### The Problem

Certain BioCal products manufactured after June 20, 2000 have been found to have pump motors operating in reverse. This can result in the linkage between the gearbox output shaft and the pump piston binding, causing the linkage to become disconnected.

Figure 1. Cutaway drawing showing Pump 1 and Pump 2 wires and terminals.

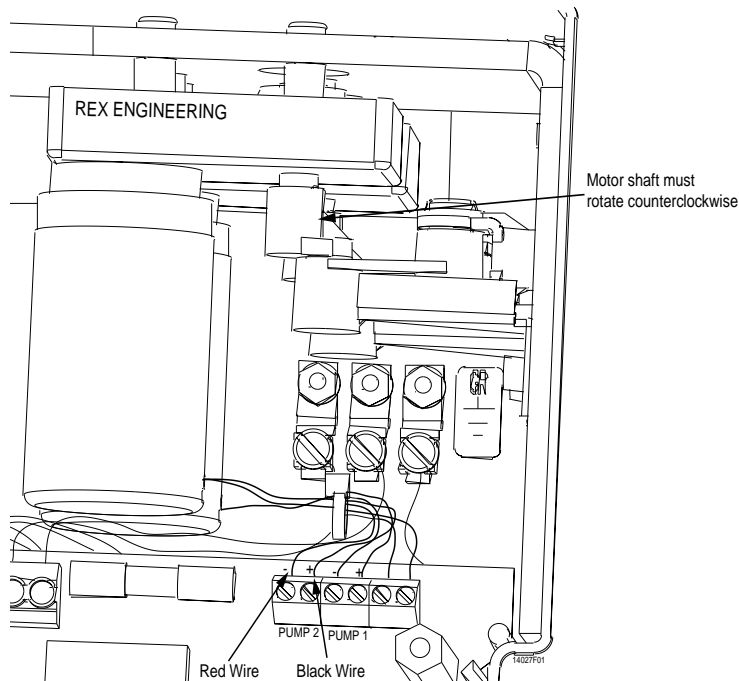
3. Find the terminal block that says PUMP 1. Disconnect the red wire from the positive (+) terminal and the black wire from the negative (-)
4. Reconnect the black wire to the positive (+) terminal, and the red to the negative (-) terminal as shown in Figure 1.

5. Repeat these steps for the PUMP 2. terminal block.
6. Attach wire harness with tie wrap to right wall of BioCal, and secure black and red wires into it as shown in Figure 2. Make sure that wire harness is far enough from pump linkage so that it doesn't catch on crank shaft.
